ADDENDUM 2

Vestavia Hill Fire Station No. 4 Expansion

DATE: **August 12, 2026**

1 FLOOR PLAN - LEVEL 1 - ANNOTATION
SCALE: 1/8" = 1'-0"

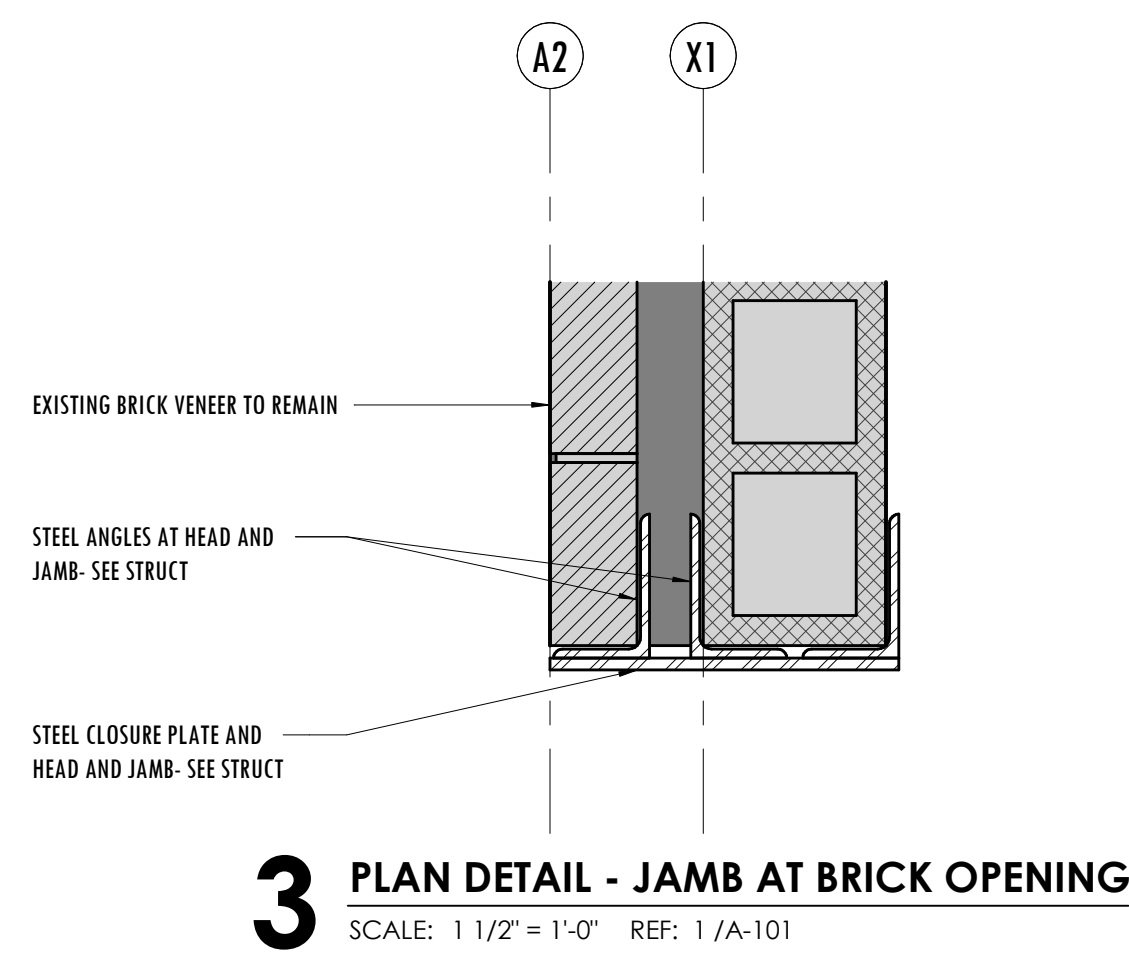
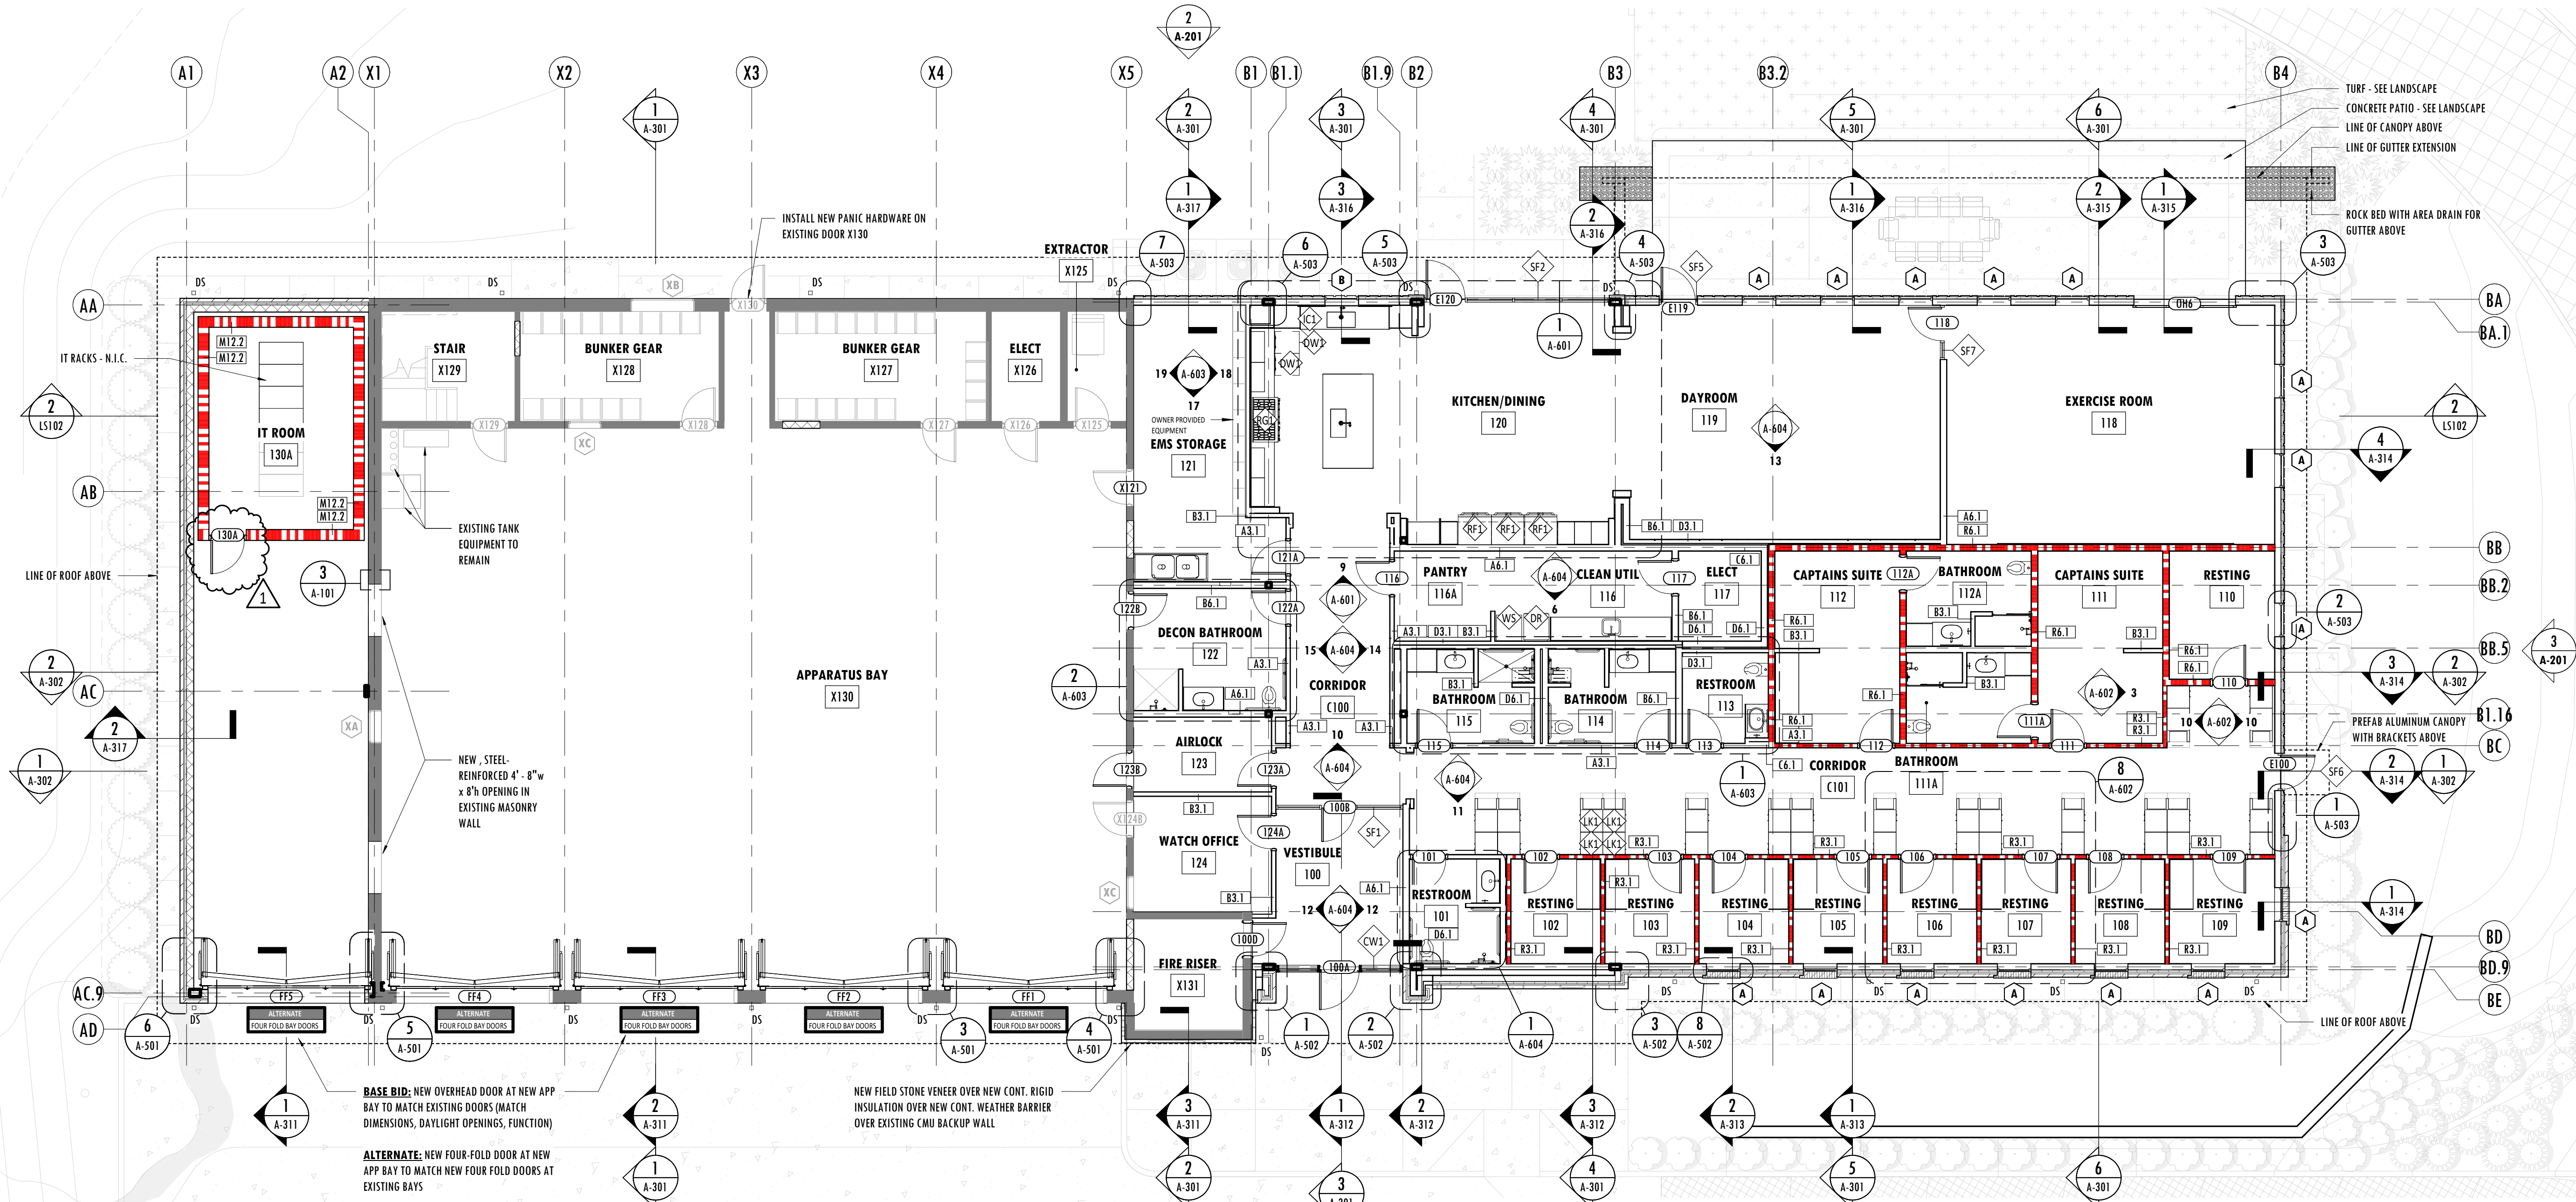
6. A-101 – FLOOR PLAN LEVEL 1:
 - a. Storm Shelter door 130A has been revised to swing out. See revision clouds.
7. A-803 – DOOR SCHEDULE:
 - a. Doors 116, 117, and 123A have been revised to Hollow Metal per bidding RFI #7 response. See revision clouds.

A-803

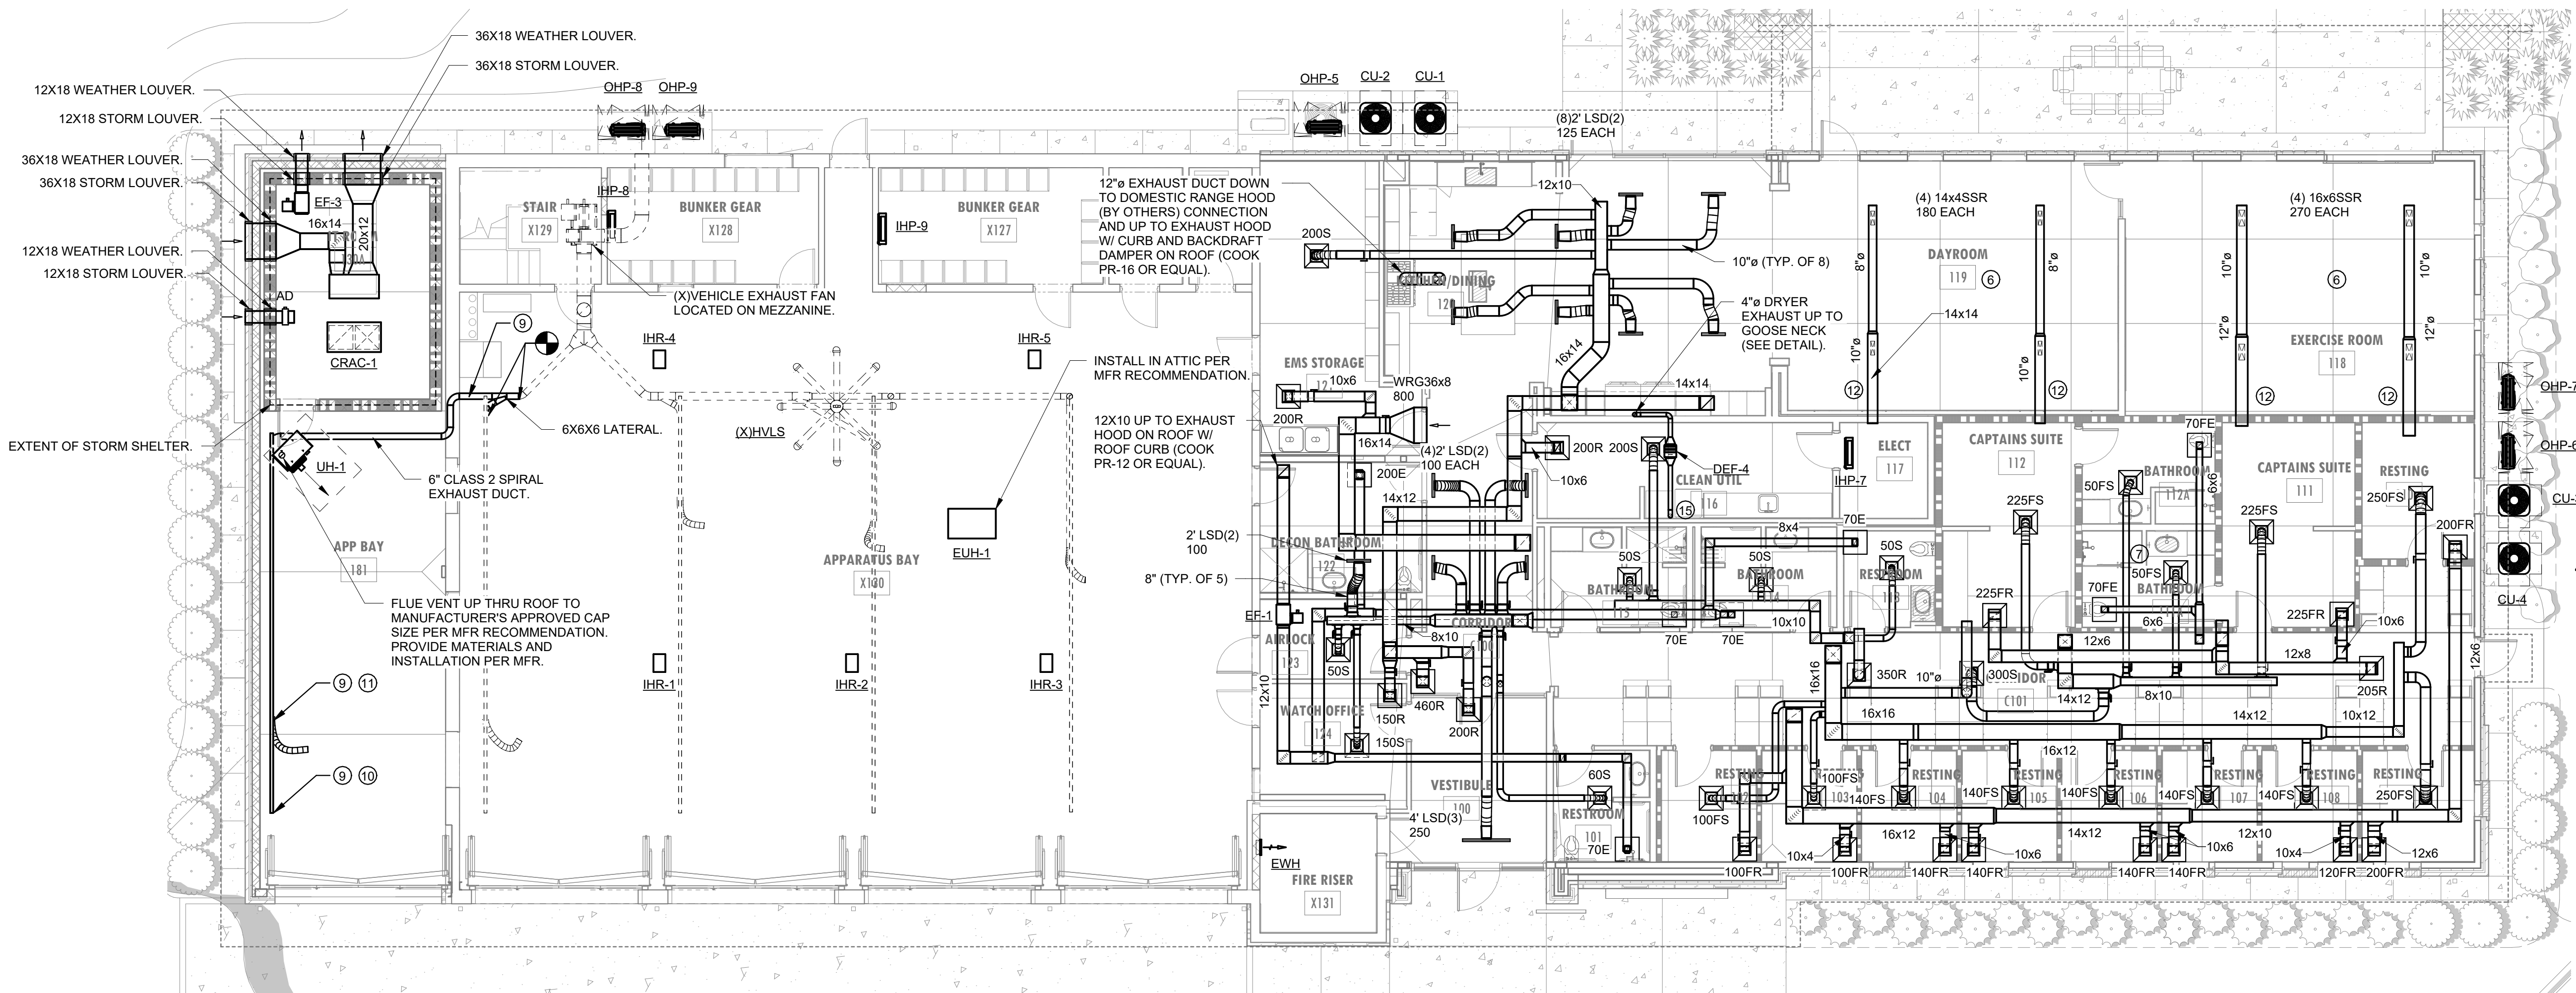
- b. Door 130A has been revised to Hollow Metal per RFI #5 response. Door frame type has been revised to F13 as part of response. See revision clouds.

- c. “ICC 500 Compliant” has been added to the comments for door 130A.

1 MECHANICAL - FLOOR PLAN - NEW WORK
1/8" = 1'-0"
0 4 8 16 24'

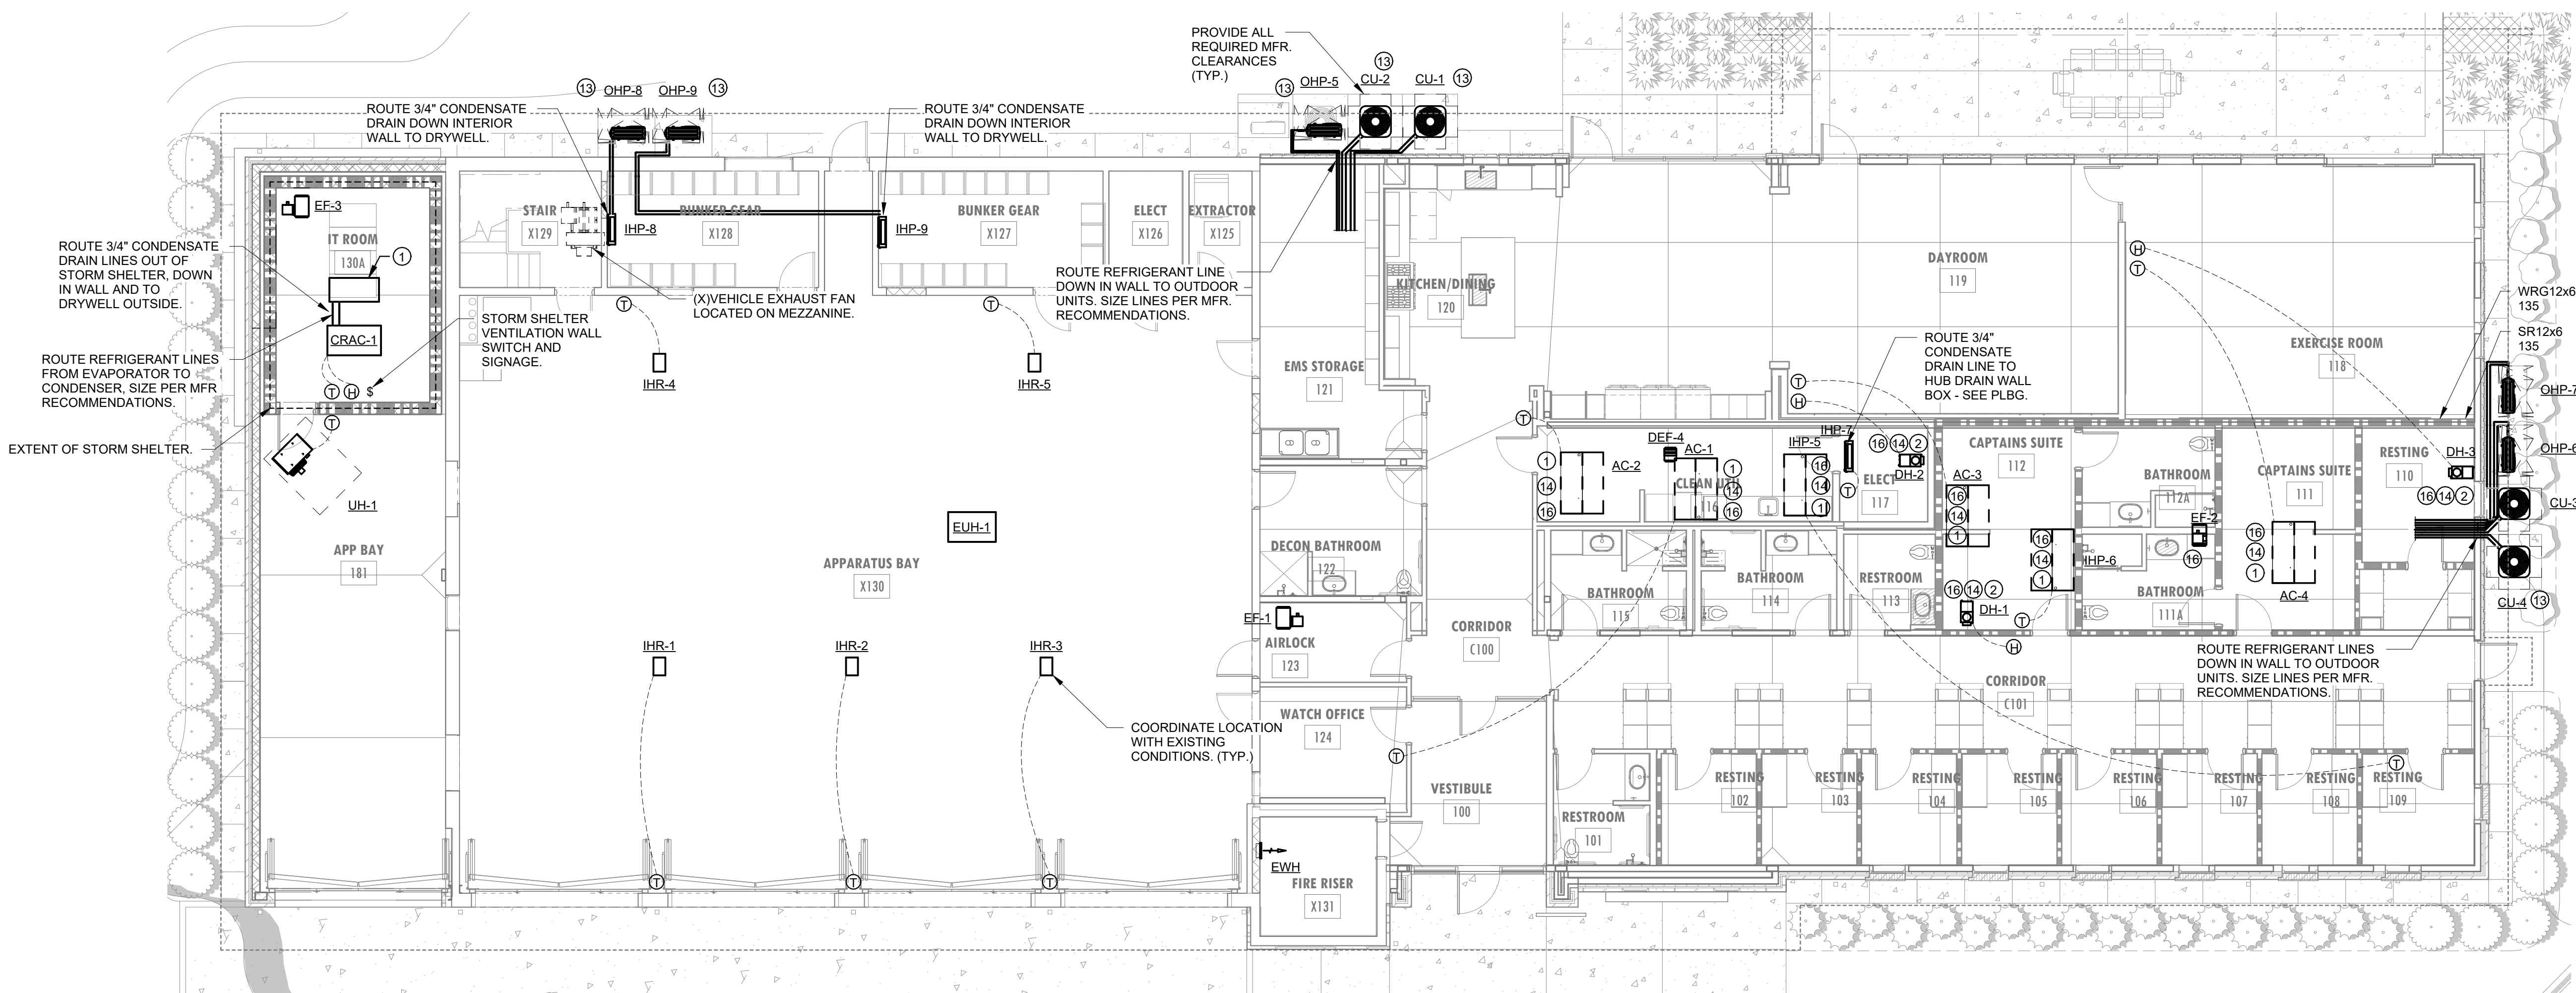
1. M-101 – MECHANICAL FLOOR PLAN:
 - a. Control diagram added and sequence updated on sheet M-101. Inverter powers the ventilation fan and damper is powered close and will open upon a loss of power.
